8A Miscellaneous Electrical Systems

The information in this appendix of the reference ABWR DCD, including all Subsections and figures, is incorporated by reference with the following departures and supplements.

FIGURE 8A-1 SITE PLAN (GROUNDING)

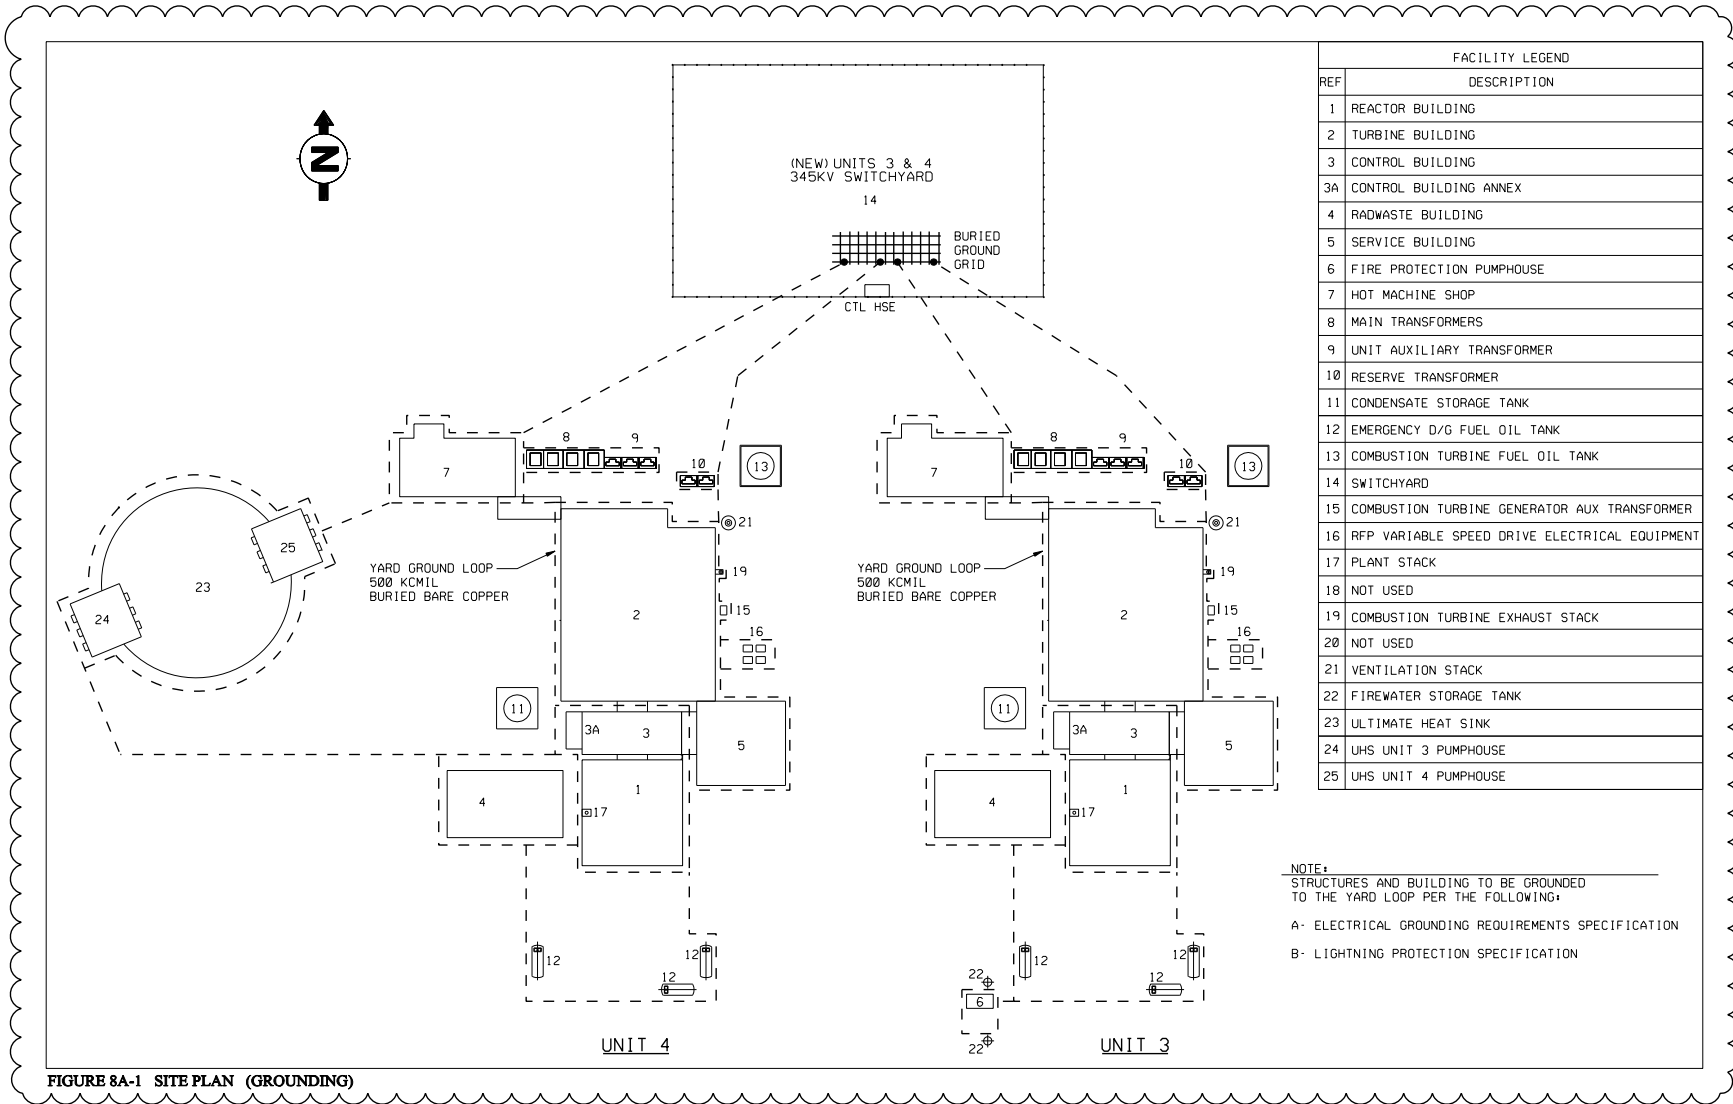
STP DEP 1.1-2 (Figure 8A-1)
